**TOWN OF BAY HARBOR ISLANDS
DEVELOPMENT AND REVIEW COMMITTEE
AGENDA
March 11, 2021**

1. Review and discussion of Site Plan Review Application by Blue Lotus Development, LLC for a proposed project development / 10 Unit Multi-Family Townhouses at 1165-1175 97th Street. Enclosed is a copy of site plans and staff report prepared by Town Planner Michael Miller.

Subject: Site Development Plan Application – 2nd Formal Submittal
Proposed Townhouse Development (10 DU)
1165-1175 97th Street
Bay Harbor Islands Acct. No. SPR20-000004
MMPA Acct. No. 01-0702-1093

SITE PLAN

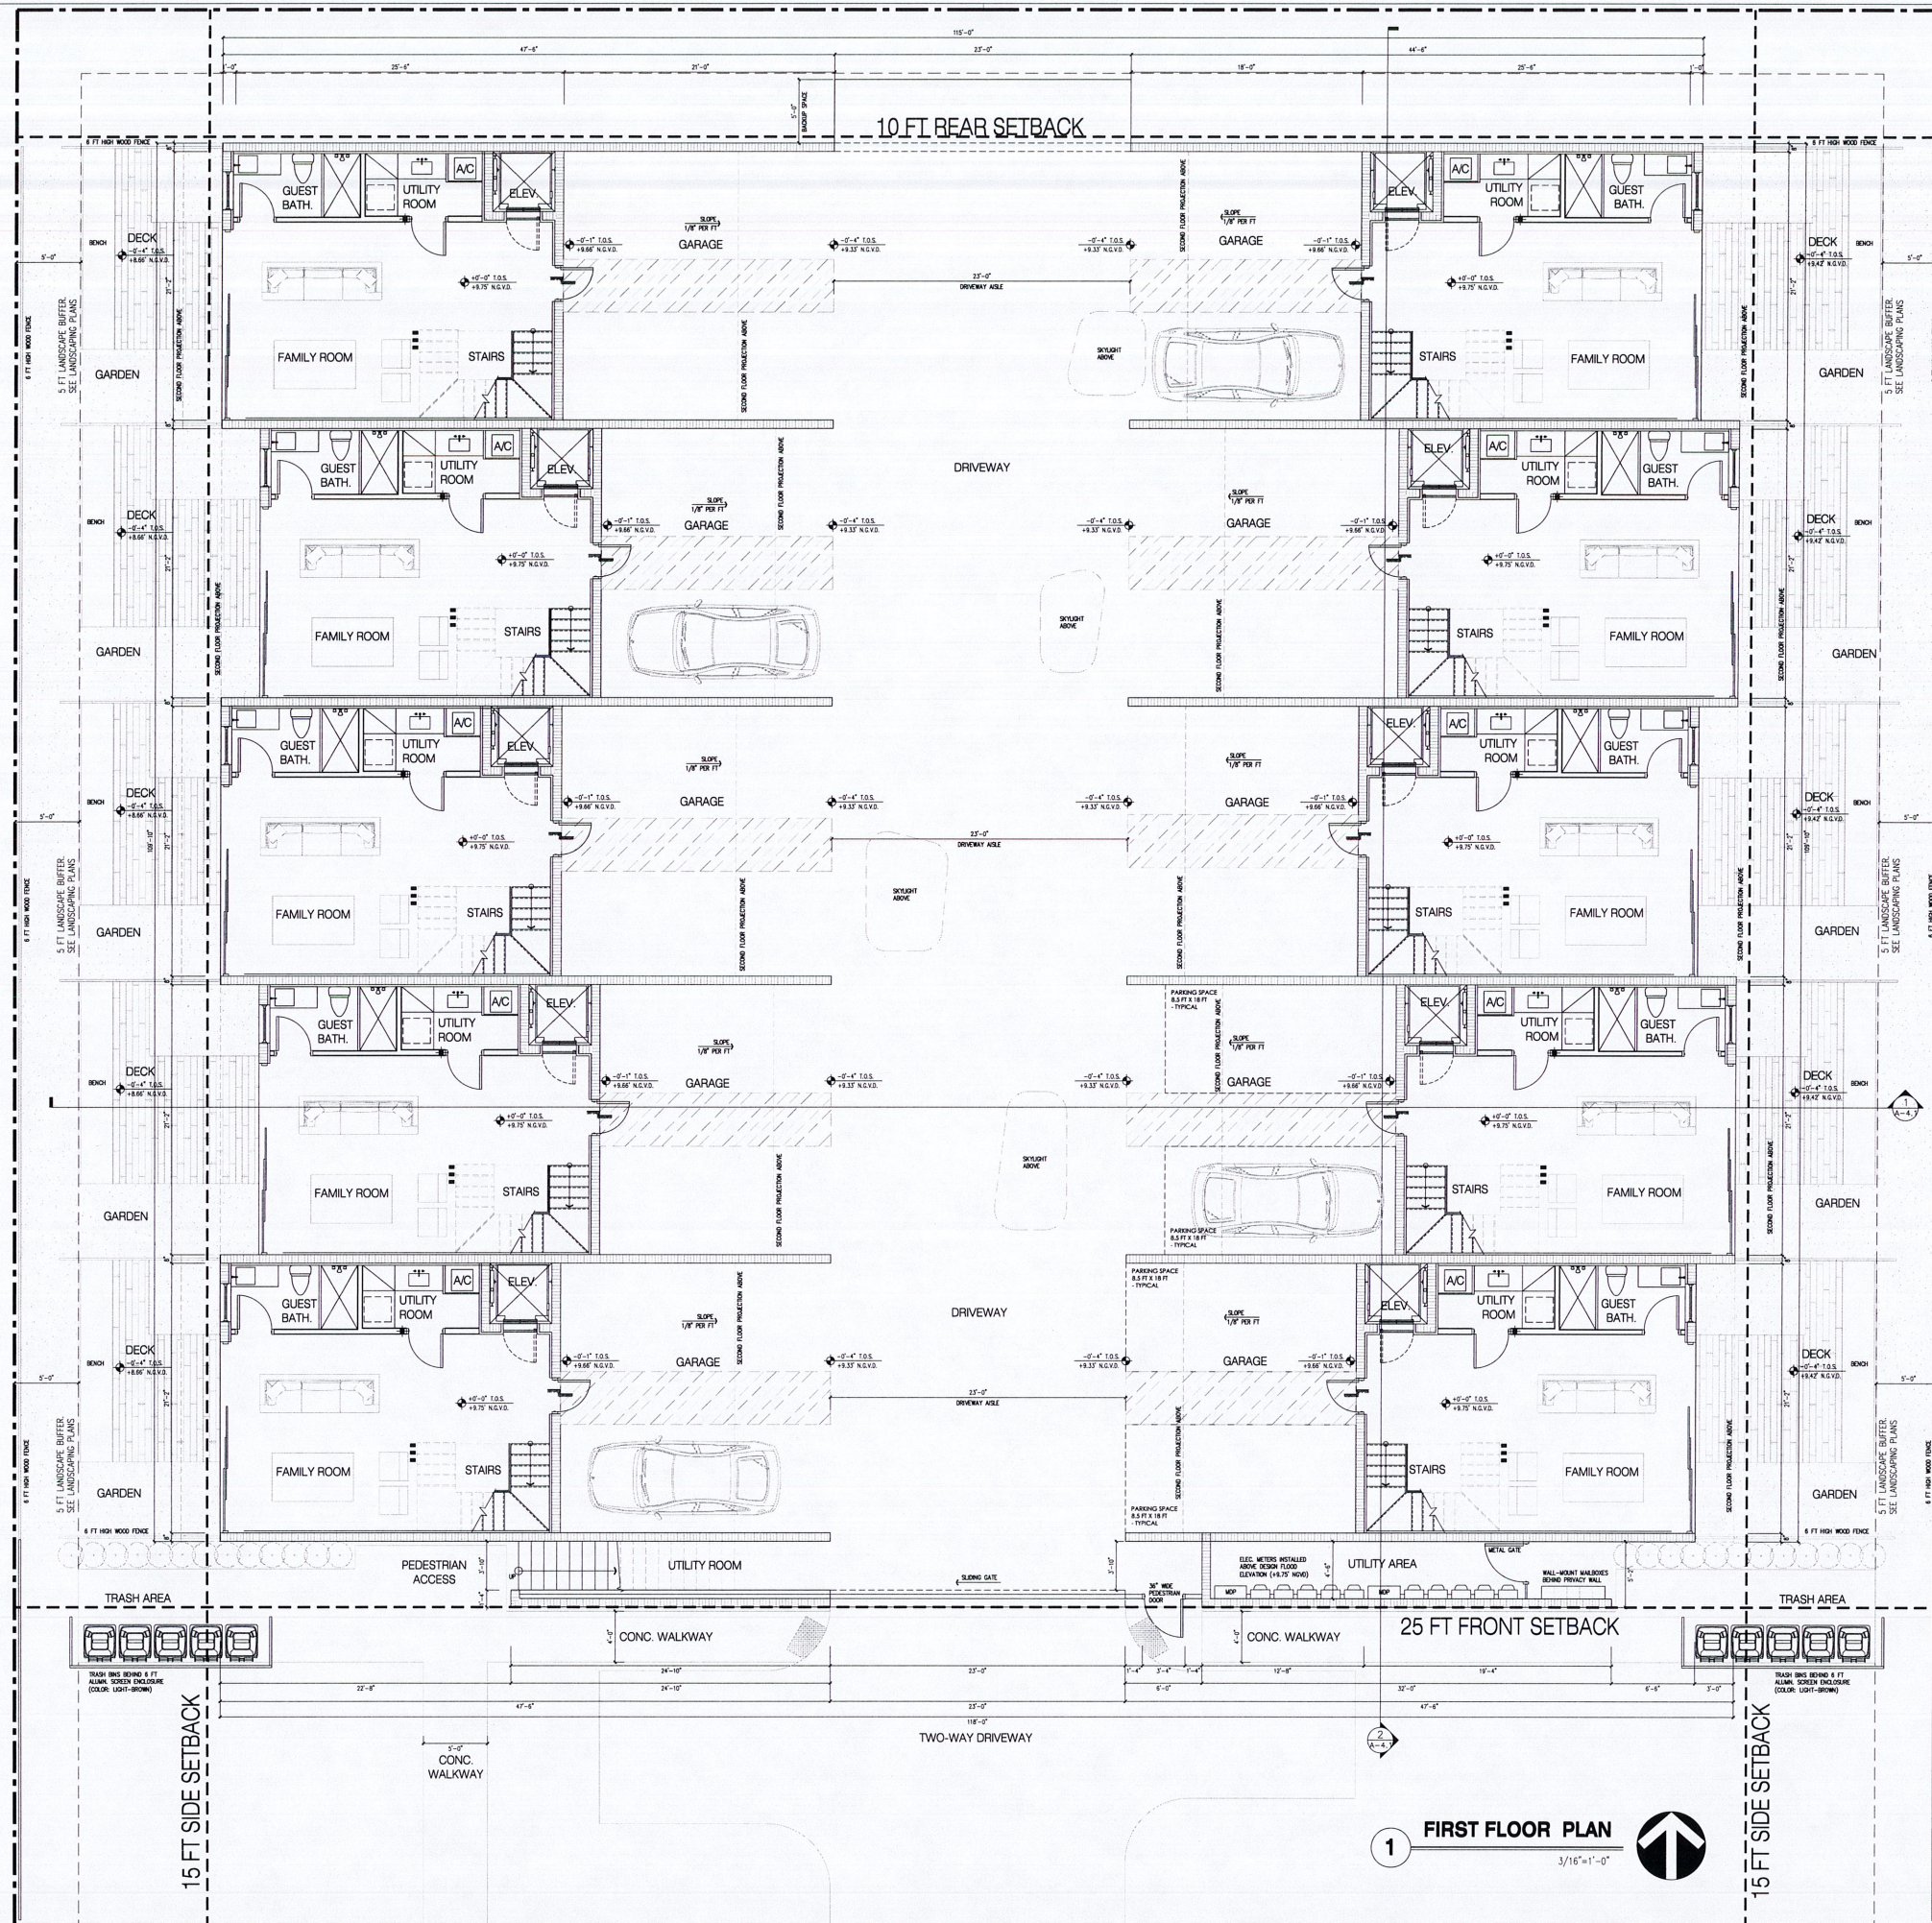
7. The Landscape Plans include an open space calculation of 12,160 sq. ft. (NOT). On Sheet A-1.0 in the Zoning Data table it states that 5,696 sq. ft. of open space is provided - MMPA believes that is the actual open space. Verify the calculation and revise the plans to be internally consistent. Open space is on the ground pervious areas only.
